TOWN OF JAMESTOWN
ZONING BOARD OF REVIEW

Application for Exception or Variation under the Zoning Ordinance

Office of the Town Planner
MEMORANDUM

TO: Jamestown Zoning Board of Review
FROM: Lisa Bryer, AICP Town Planner for The Jamestown Planning Commission
RE: Zoning Section 82-314: High Groundwater Table and Impervious Overlay District, **Sub-District A**
Brian and Ada Haskell: AP 14, Lot 70; 66 Seaside Drive, Jamestown, RI
DATE: November 2, 2023

Site Plan Existing and New Addition	
PROJECT NO.	66 Seaside Drive Jamestown, RI 02836
DATE	02/21/2023
SCALE	1/16" = 1'
PROJECT	G-101
DESIGNER

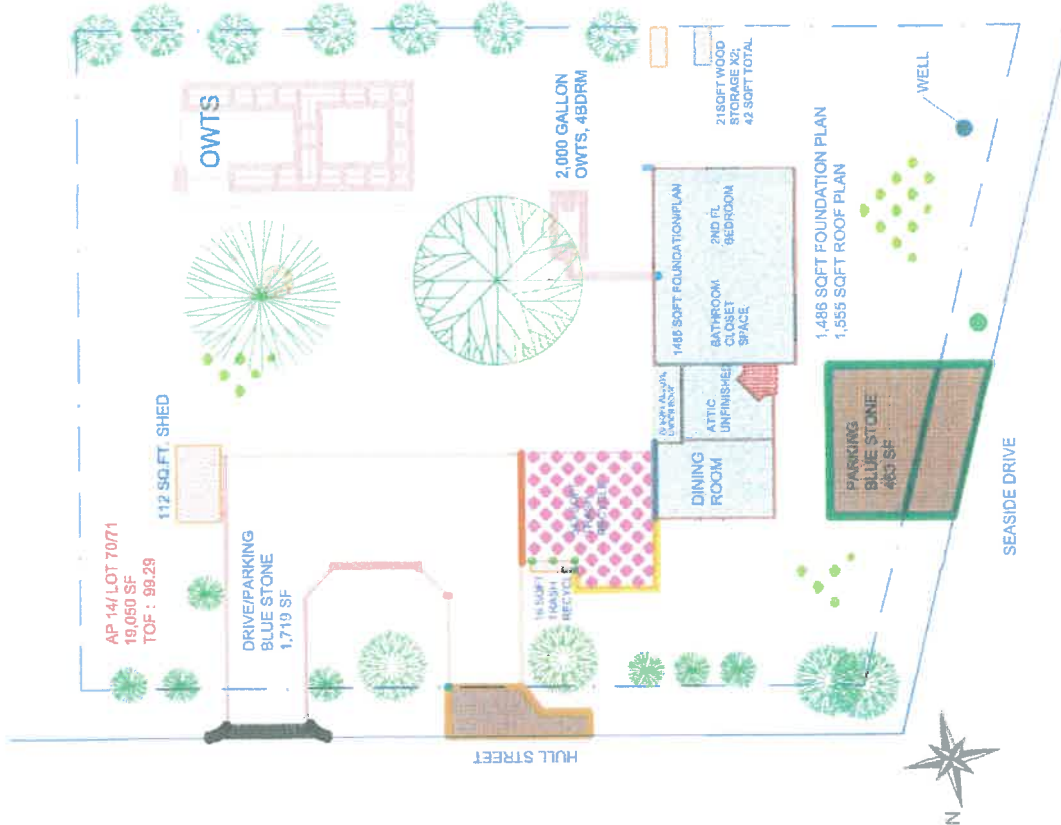
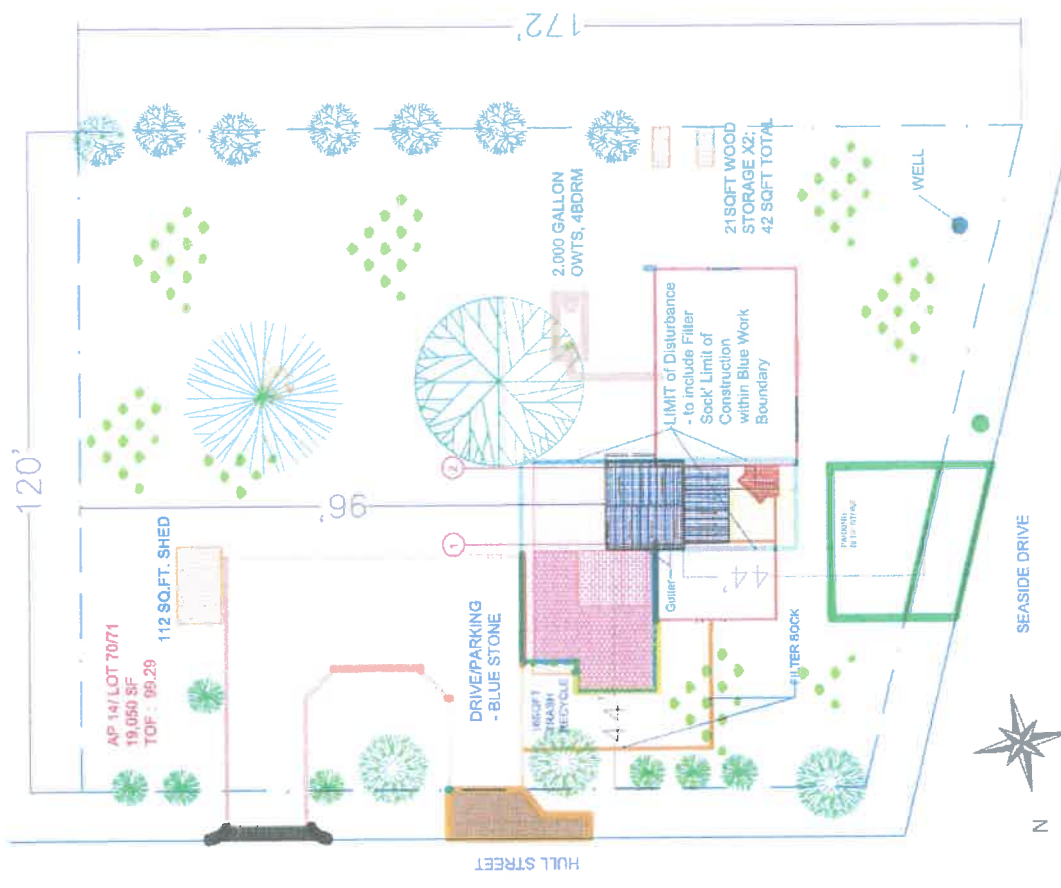
5. There is no driving over or parking on the permeable pavers;
6. There is no roof over the “carport” as labeled and change wording to “patio”;
7. Clarification is needed for plans to be labeled as existing plans and proposed plans;

Notes: 2) The Plan referenced above dated 6/21/23 shall be updated prior to Zoning Board submittal per Conditions 6 and 7 above.
3) The Operation and Maintenance plan (attached) must be amended to remove loading and unloading on the existing patio (labeled “carport”), as it is not to be driven over, and recorded with the Zoning Board Approval in the Office of the Town Clerk.

Site Plan - Part	
Patio - Retention	
Addition	
PROJECT NUMBER	65 Seaside Drive Jamestown, RI 02835
DATE	8/21/2023
SCALE	3/16" = 1'
G-103

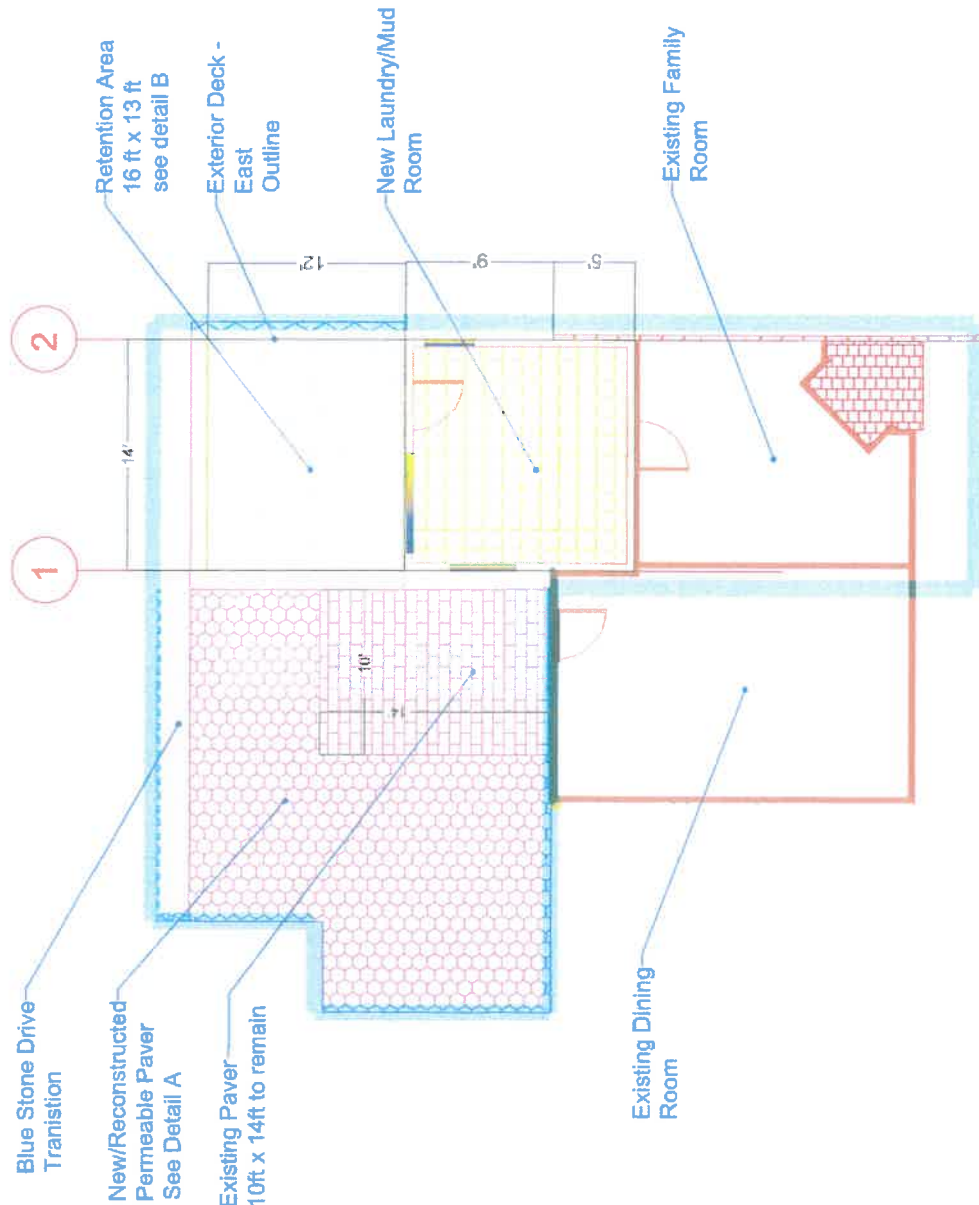
3. After installation, maintenance and inspection of the OWTS shall continue as required by the Town Onsite Wastewater Management Ordinance;
4. The permeable pavers shown on the approved site plans must be installed and maintained as outlined on the approved site plan and the submitted Operation and Maintenance Plan. The installation of the permeable pavers must be in accordance with the Rhode Island Stormwater Manual;
